**IEEE P802.15  
Wireless Personal Area Networks**

Project	IEEE P802.15 Working Group for Wireless Personal Area Networks (WPANs)
Title	Sensing MSC and description
Date Submitted	3 October 2024
Source	Billy Verso (Qorvo), <span style="float: right;">billy.verso at qorvo.com</span>
Re:	IEEE P802.15.4ab
Abstract	Comment Resolutions for selected comments on the LB207 / P802.15.4ab D01.
Purpose	This document provides text changes intended to be part of the final IEEE Std 802.15.4ab (amendment to IEEE Std 802.15.4), as part of resolving selected comments from the consolidated spreadsheet (doc 15-24-0371) that have been assigned to the author to resolve.
Notice	This document does not represent the agreed views of the IEEE 802.15 Working Group or IEEE 802.15.4ab Task Group. It represents only the views of the participants listed in the "Source(s)" field above. It is offered as a basis for discussion and is not binding on the contributing individual(s) or organization(s). The material in this document is subject to change in form and content after further study. The contributor(s) reserve(s) the right to add, amend or withdraw material contained herein.

**10.39.4.8 Control of HRP UWB sen

**Figure A—Example message sequence chart for sensing**

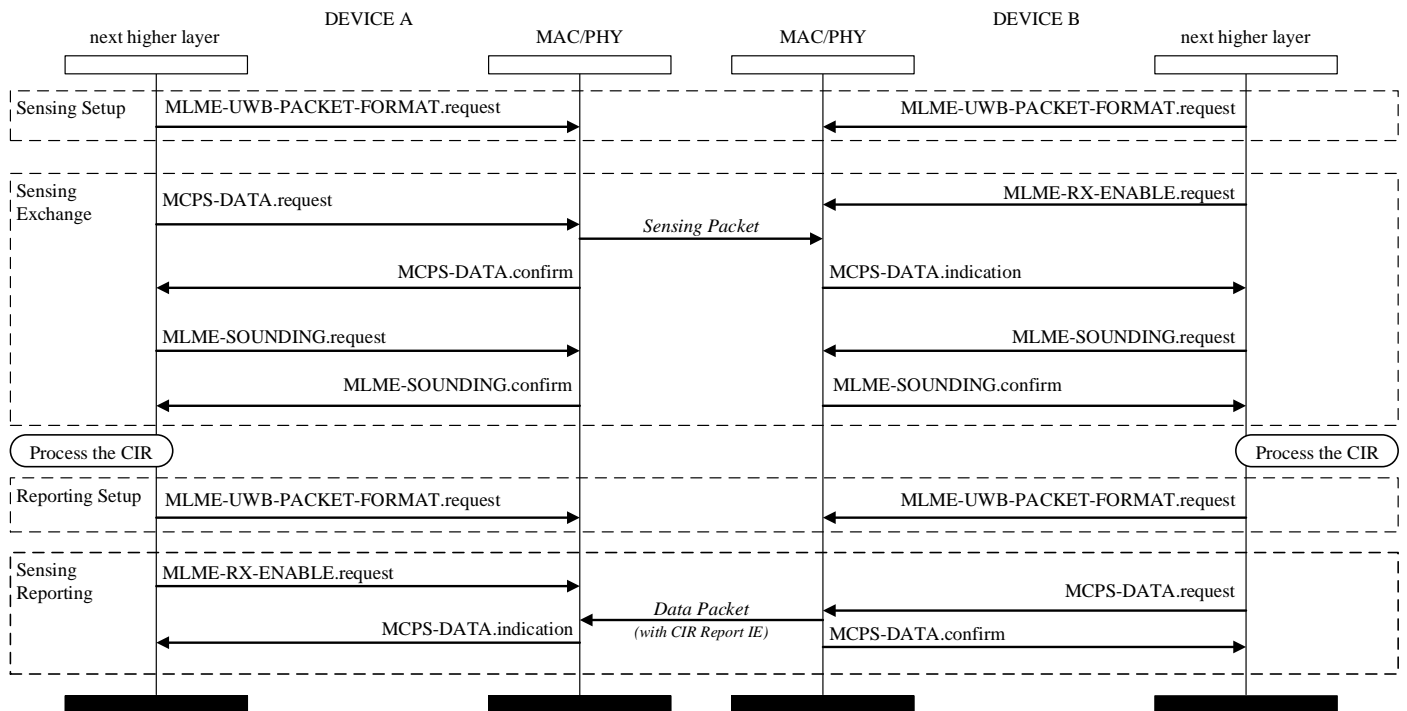
Index	page	clause	line	Comment	Proposed Change
1241 (Billy)	129	10.39.4	23	We are missing a subclause about the control of sensing from the next higher layer perspective and how it all hangs together. I think the interactions should be based on the thoughts captured in 15-23-0208. It should employ a message sequence chart to illustrate the interactions.	I will prepare a submission to cover this, for consideration to be inserted in a suitable place in 10.39

The commenter (me) said he would prepare a submission to provide the missing subclause, and this document (15-24-0557-00) is it. This is based on 15-23-0208.

The proposed resolution for this comment, is “Revised”, with the resolution being to insert the text & figure from the subsequent pages of this submission into the draft as a new subclause.

*Insert the following as a new subclause within and at the end of the existing 10.39.4, (e.g. as 10.39.4.8):*

Figure A presents a message sequence chart that illustrates both monostatic sensing and multistatic sensing cases. In the figure, device A is a sensing transmitter sending a sensing packet to device B which is a sensing receiver. Device B receives the packet from device A and subsequently sends a CIR report to device A, which illustrates a possible behavior of a device participating in multistatic sensing. Device A also receives the reflection of its transmitted packet from the environment which illustrates the behavior of the monostatic sensing case.

With reference to Figure A, the next higher layer in each device uses the MLME-UWB-PACKET-FORMAT.request primitive to set the sensing packet format, e.g., with a PacketFormat parameter value of SENS\_PACKET\_0 to select the SENS packet configuration zero shown in Figure 194.

The next higher layer in device B, the sensing receiver, issues an MLME-RX-ENABLE.request to turn on its receiver in good time to receive the sensing packet it is expecting as it participates in multistatic sensing, and, the next higher layer in device A, the sensing transmitter, issues the MCPS-DATA.request primitive with the SensReceive parameter set to TRUE to initiate the sensing packet transmission with its receiver also turned on so that it can perform monostatic sensing.

On device A the MCPS-DATA.confirm primitive from the MAC tells the next higher layer that the sensing packet transmission has completed. To extract the CIR data for its monostatic sensing processing, the next higher layer in device A then issues an MLME-SOUNDING.request (with FormatSpecifier parameter value of IQ\_FORMAT), and the CIR data is delivered by the MAC issuing the MLME-SOUNDING.confirm in response.

On device B the MCPS-DATA.indication primitive from the MAC tells the next higher layer that the sensing packet has been received, and the next higher layer uses the MLME-SOUNDING.request primitive to extract the CIR for its sensing processing.

For the reporting phase, the next higher layers in both devices issue the MLME-UWB-PACKET-FORMAT.request primitives to set the packet format appropriately to carry the reporting phase payload, i.e., a PacketFormat parameter value of BASIC\_PACKET. In the Figure A example device B is reporting to device A, which would be done once the appropriate processing of the CIR has completed.

The next higher layer in device A, issues an MLME-RX-ENABLE.request to turn on its receiver in good time to receive the report it is expecting from device B, and the next higher layer in device B, issues the MCPS-DATA.request to initiate the transmission of the report, e.g., sending a frame carrying the CIR Report IE. Acknowledged transmission might be used here.

On device B, the MCPS-DATA.confirm primitive issued by the MAC tells the next higher layer that the transmission has completed, while on device A, and the MCPS-DATA.indication primitive delivers the received report to the next higher.

That completes a single round of sensing. A sensing application would typically repeat the flow illustrated in Figure A at regular intervals and observe the changing CIR data to perform its sensing function.
